# Access Compliance Report

## Public Rights-of-Way

Intersection ID: 7347	Main Street: MOORES_CHAPEL_RD	Cross Street: SULLINS_RD	Location: E
ADA ID: 742900A36792	Ramp Type: BlendTrans1	Initial Pass/Fail: Fail	Overall Compliance: No
			Severity Score: 21.25

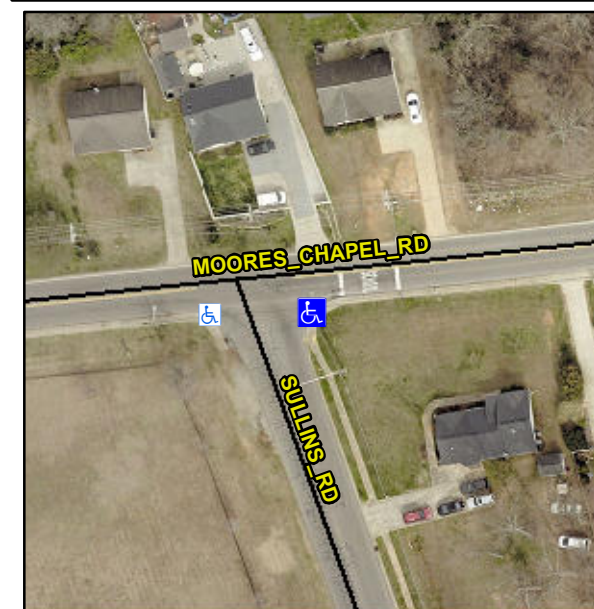
**Not Found, R304.5.1, R304.5.3**

Compliance	Description	Data	Compliance	Description	Data
N/A	Ramp Length (in)	62.0	Yes	BlendTrans Slope (%)	2.6
No	Ramp Width (in)	43.0	No	BlendTrans XSlope (%)	6.1
N/A	Flare Type LT	N/A	N/A	Flare Type RT	N/A
N/A	Flare Slope LT (%)	N/A	N/A	Flare Slope RT (%)	N/A
N/A	Flare Traversable LT?	N/A	N/A	Flare Traversable RT?	N/A
N/A	Landing Length (in)	N/A	N/A	DWS Provided?	N/A
N/A	Landing Width (in)	N/A	N/A	DWS Contrast?	N/A
N/A	Landing Slope (%)	N/A	N/A	DWS Length (in)	N/A
N/A	Landing X Slope (%)	N/A	N/A	DWS Full Width?	N/A
N/A	Landing Curb? (Y/N)	N/A	N/A	DWS Offset (in)	N/A
N/A	Shared Landing?	N/A			
N/A	Gutter Ponding?	N/A	N/A	Gutter Slope (%)	N/A
N/A	Gutter Lip Ht (in)	0.5	N/A	Gutter X Slope (%)	N/A
N/A	Painted X Walk1?	No	N/A	Painted X Walk2?	N/A
	X Walk 1 Direction	To W		X Walk 2 Direction	N/A
	X Walk 1 Width (in)	N/A		X Walk 2 Width (in)	N/A
	X Walk 1 Slope (%)	9.2		X Walk 2 Slope (%)	N/A
	X Walk 1 X Slope (%)	2.2		X Walk 2 X Slope (%)	N/A

N/A	Ramp inside XWalk1?	N/A	N/A	Ramp inside XWalk2?	N/A
	Road Slope (%)	2.2		Clear Space?	N/A
	Road X Slope (%)	9.2	N/A	Clear Space to XWalk (in)	N/A
N/A	Any Obstructions?	N/A	N/A	Storm Grate/Utility Hazard?	N/A
	Obstruction Type			Storm Grate/Utility Type	
		N/A			N/A
			Yes	Surface Condition? (G/P)	Good
			No	Curb Slope (%)	23.0

**Remove & Replace Curb Ramp With Two New Directional Ramps or Equivalent.**
